ADDENDUM #2

1.1 PROJECT INFORMATION

- A. Project Name: **Long Sands Beach Bathhouse.**
- B. Owner: **Town of York, York, Maine.**
- C. Engineer: **Ransom Consulting, Inc., 400 Commercial Street, Portland, Maine.**
- D. Engineer Project Number: **151.06011.**
- E. Date of Addendum: **October 14, 2016.**

Sheet No:
C-101
Sheet 4 of 9

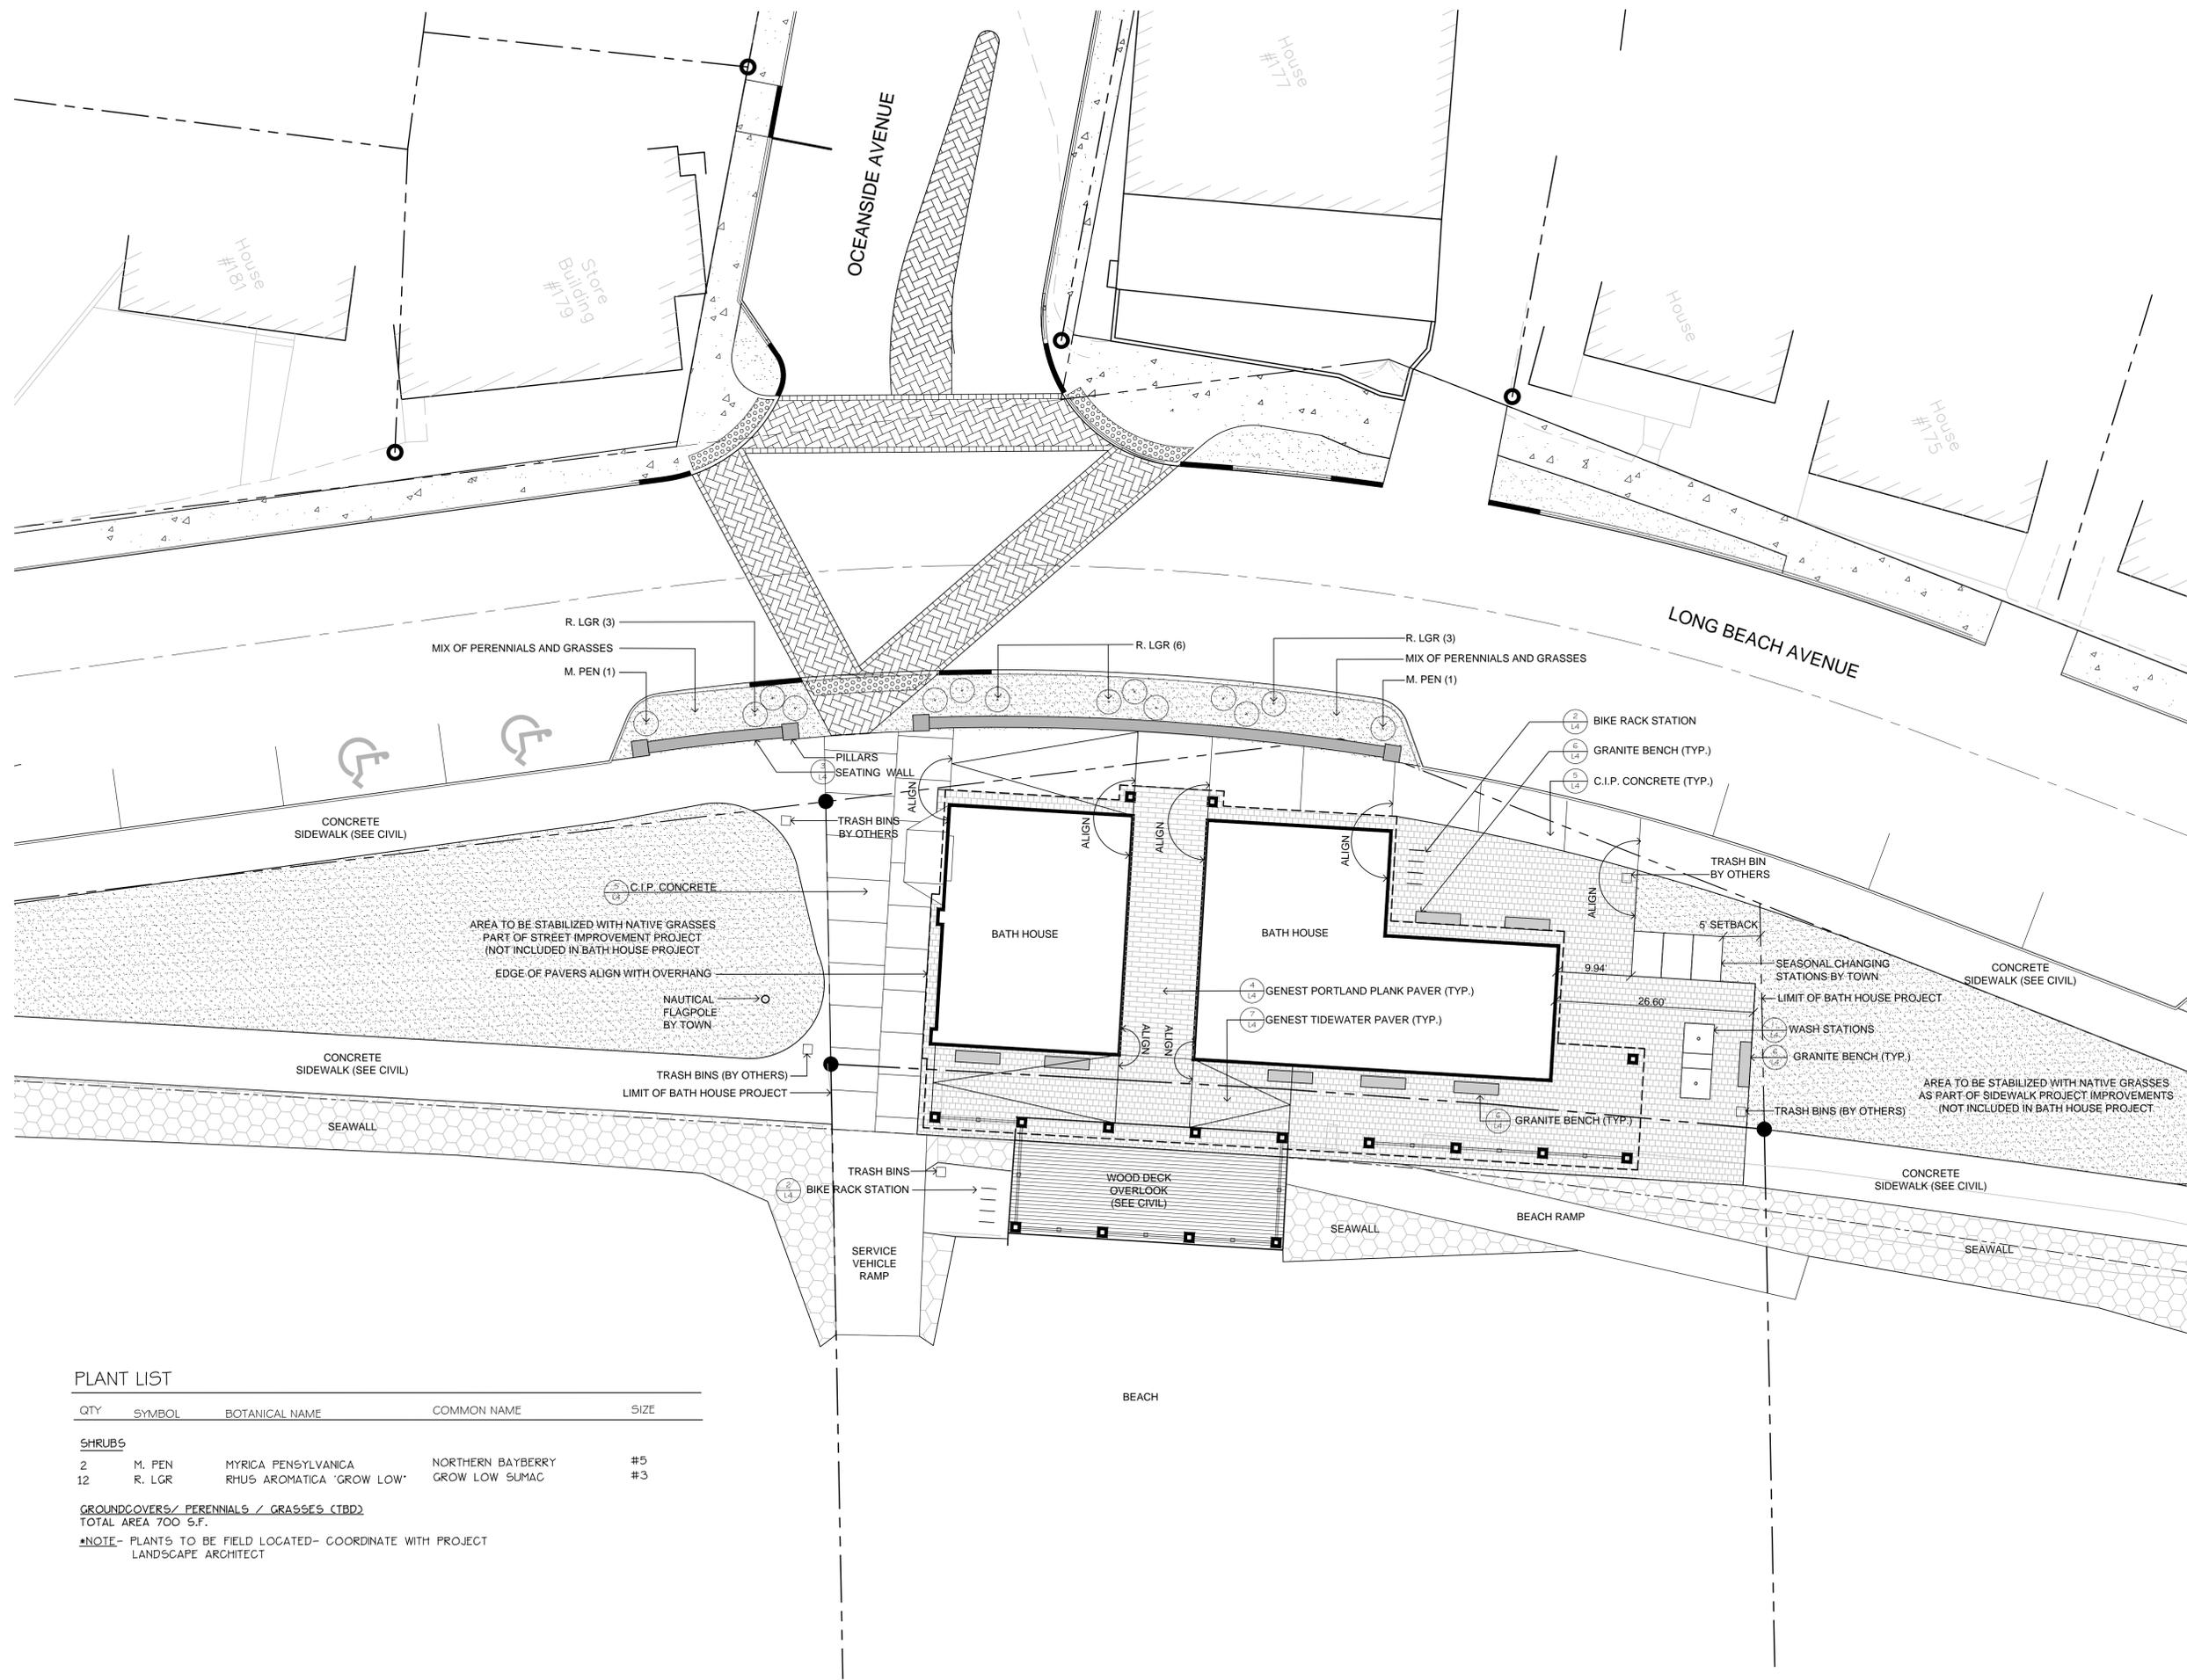
3. Replace the Cover sheet with the attached to reflect the modifications to the plan list
4. Replace drawings C-101 Site Layout and Utility Plan, E2.01-Electrical Plan and E3.01 Legend, Notes, One-Line and Panel Schedule with the attached drawings, so as to relocate the layout of power, telephone and CATV from the pole to the building.
